City Planning Commission
Sacramento, CA

Subject: Special Permit to replace an existing directional and identification pole sign for Point West Plaza with a triangular monument sign on 14+ acres in the Shopping Center - Review (SC-R) zone and Point West PUD.

Location: 1890 Arden Way

P87-173

EXHIBIT A-1

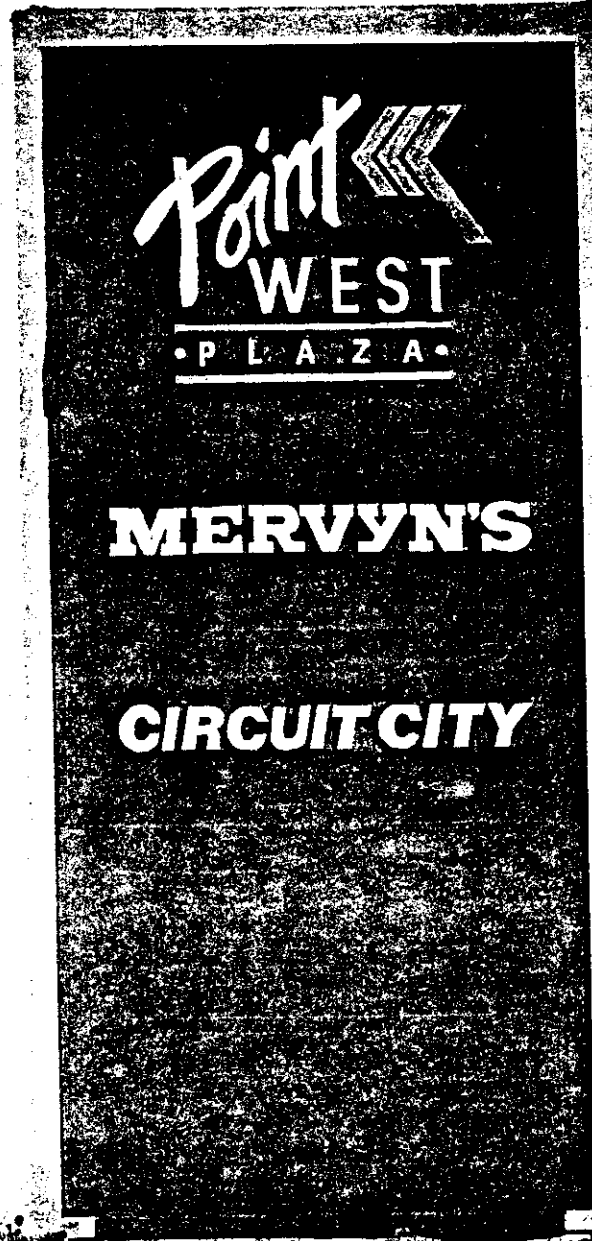
Planning Staff met with representatives of the Point West Plaza Shopping Center and Ellis and Ellis Sign Company on June 18, 1987. They agreed with staff's original recommendation that the sign may be too cluttered with all the shopping center tenants on the proposed sign. They revised the proposed sign placing the Point West Plaza name and logo at the top of the sign and allowing individual signage for the three major shopping center tenants below the name and logo. Proposed height is 12 feet, the maximum allowed for a monument sign by the City Sign Ordinance. Proposed colors are white copy on a burgundy background. These colors will match the proposed colors of the future remodeling that the shopping center owners are planning.

Planning staff finds that the proposed sign is in harmony with the purpose of the Sign Ordinance to eliminate excessive and confusing sign displays and recommends approval of the revised sign proposal.

1. The sign copy shall indicate "Point West Plaza" with logo as indicated on the revised plans (Exhibits A-1 and A-2). Individual signage for a maximum of three major tenants may be listed below the shopping center name and logo.
2. Maximum sign height shall be 12 feet.
3. Sign colors shall be white copy on burgundy background.

4. The sign shall be set back a minimum of 10 feet from the Arden Way property line and the driveway.
5. No sign copy of any type shall be permitted on the back side of the sign which faces the shopping center.
6. The existing Point West Plaza sign on Arden Way shall be removed when the new detached monument sign is located on the subject site.

EXHIBIT 1

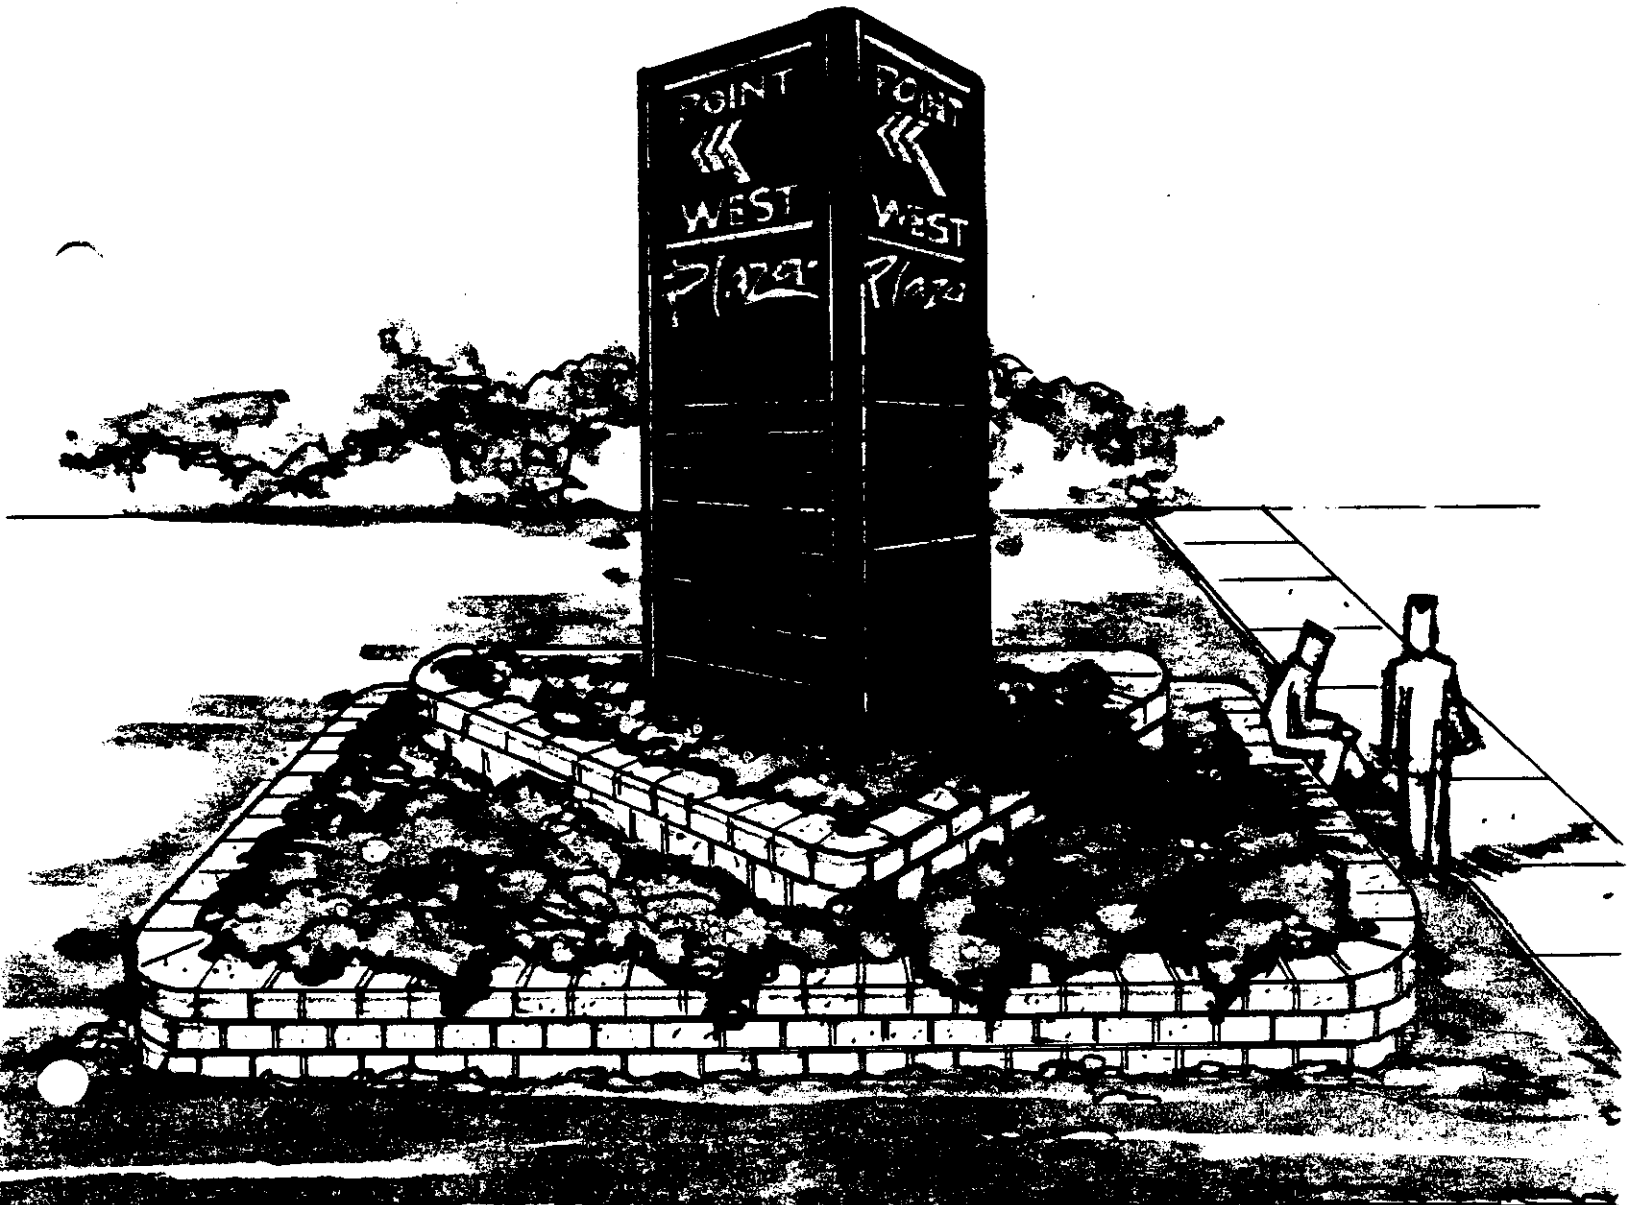
The applicant has presented two revised versions of the proposed sign with the Point West Plaza name (Exhibits 1 and 2). The applicant has indicated that the smaller tenants' shops in the shopping center are not visible from the public right-of-way and need some sort of name identification from Arden Way. The applicant would prefer a 12' high sign which indicates the Point West Plaza name and logo at top with a 3' x 5' copy area for the three anchor tenants (1' x 5' per tenant) and a 3.5' x 5' copy area for the seven remaining tenants (.5' x 5' per tenant) (Exhibit 2).

Planning staff agrees with the applicant that due to the large building setback of the shopping center from Arden Way and the irregular shape of the shopping center and existence of large trees, many of the small tenants do have an identification problem. Staff, however, finds that all of the tenants can be adequately identified on a 10' high sign if the copy area for each tenant is the same size. This should not create a problem as the attached sign area for each of the anchor tenants is larger than the sign area for the smaller tenants and is visible from the public right-of-way, and the purpose of listing the tenants on the monument sign is to assist the smaller tenants. Staff, therefore, recommends that the maximum height of the sign be 10'; the top of the sign indicate the Point West name and logo and the remaining sign area can be used for tenant identification with all tenants utilizing approximately the same copy area (Exhibit 3).

1. Revised plans for the sign shall be submitted for Planning Director review and approval prior to issuance of sign permits. The revised plans shall indicate the following:

- a. the sign copy shall indicate "Point West Plaza" with a logo underneath the main copy identification; tenants of the shopping center complex may be listed in smaller size copy;

- b. the maximum height of the sign shall be 10 feet, including base, as shown in Exhibit 3. The concrete/masonry base shall match the color of the shopping center building;

- c. a color board or colored rendering of the sign shall be submitted for Planning Director review and approval;
 - d. the sign shall be set back a minimum of 10' from the Arden Way property line and the driveway;

- e. no sign copy of any type shall be permitted on the back side of the sign facing the shopping center.
2. The existing Point West Plaza sign on Arden Way shall be removed when the new detached monument sign is located on the subject site.

EXHIBIT A

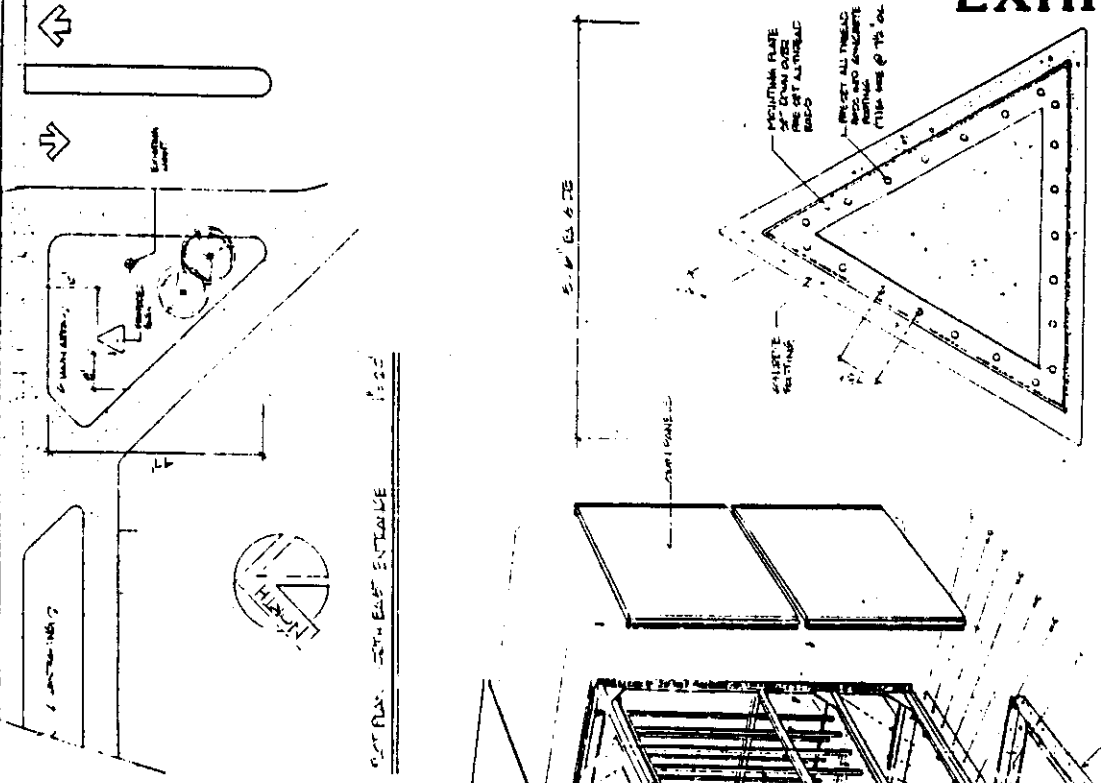
The sign is proposed to be triangular in shape and constructed out of fiberglass panels which slide into an aluminum frame (Exhibit A). The proposed sign is 12 feet, 3 inches in height with each side of the sign approximately 12 feet by 5.5 feet. Copy is proposed for two sides of the sign with the side of the sign facing the Shopping Center remaining blank. Proposed colors are aqua and white letters on a plum background. The sign would be internally illuminated with neon tubes.

Planning Staff finds that the sign copy is inappropriate in that it identifies major tenants but not the Point West Plaza Shopping Center as a whole. The purpose of the directional and identification sign is to identify the project as a whole not each tenant of the shopping center. In similar PUD'S with shopping center components, the Planning Commission has allowed detached identification signs which identify the shopping center and its major tenants (Examples: University Village Shopping Center with name of one major tenant, and Lakecrest Village Shopping Center with the names of the three major tenants.) Planning Staff, therefore, recommends that the sign copy be redesigned to indicate "Point West Plaza" with logo, if desired. The names of the two major tenants, "Mervyns" and "Circuit City," may be listed below in smaller size copy. No other tenant names, however, should be indicated on the proposed sign. The revised sign would be in harmony with the purpose of the Sign Ordinance to eliminate excessive and confusing sign displays.

The Point West Architectural Review Committee has reviewed the proposed signs and has concerns regarding the height of the sign (Exhibit B). The Committee has indicated that they believe that the sign should not exceed six feet in height. Section 5-A-5 of the Point West PUD Guidelines indicate regulations for monument signs which identify a building on one parcel and restricts these signs to six feet in height and 32 square feet in area. The proposed sign, however, is similar to project identification sign described in Section 5-D-6 (Special Signs) of the PUD guidelines and

its height may be regulated by Special Permit. Planning Staff finds that, as the project identification sign, the proposed sign should be allowed to exceed six feet in height so that it can stand out from other detached signs in the area. The recommended reduction in sign copy, however, does not require a 12 foot high sign. Staff, therefore, recommends that the sign height be reduced to 10 feet. The applicant has indicated that the sign panel system would be able to handle the reduction to 10 feet.

Planning Staff also believes that the proposed sign would be more compatible with the Shopping Center if it had a sign base composed of materials similar to the Shopping Center. Planning Staff, therefore, recommends that a minimum 1 1/8 inch base of masonry block similar to the tan color of the Shopping Center be placed at the bottom of the sign. (staff amended to...a minimum 12 inch base...)

1. Revised plans for the sign shall be submitted for Planning Director review and approval prior to issuance of sign permits. The revised plans shall indicate the following:

- a. The sign copy shall indicate "Point West Plaza" with a logo if desired. Underneath the main copy identification, the two major tenants of the Shopping Center, may be indicated in smaller size copy. No other tenant names are permitted on the project identification sign.

- b. The maximum height of the sign shall be ten (10) feet.
 - c. A color board or colored rendering of the sign shall be submitted for Planning Director review and approval.

- d. The sign shall be setback a minimum of 10 feet from the Arden Way property line and the driveway.
 - e. No sign copy of any type shall be permitted on the back side of the sign facing the Shopping Center.

- f. A minimum 1 1/8 inch base of masonry block similar to the tan color of the Shopping Center shall be placed at the bottom of the sign. (staff amended to...A minimum 12 inch base...)

EXHIBIT B

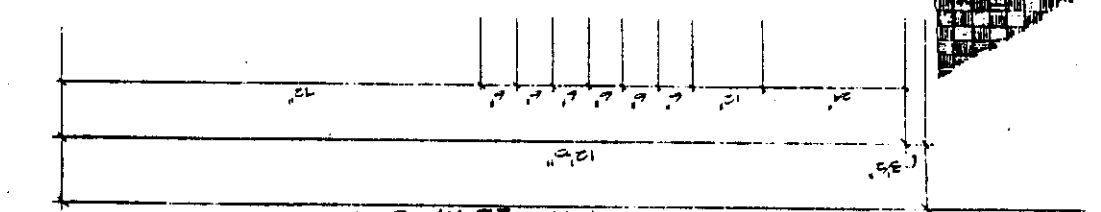
We have reviewed the enclosed drawing. The drawing does not conform with the CC&Rs in that the monument sign exceeds the height and size specified in the CC&Rs.
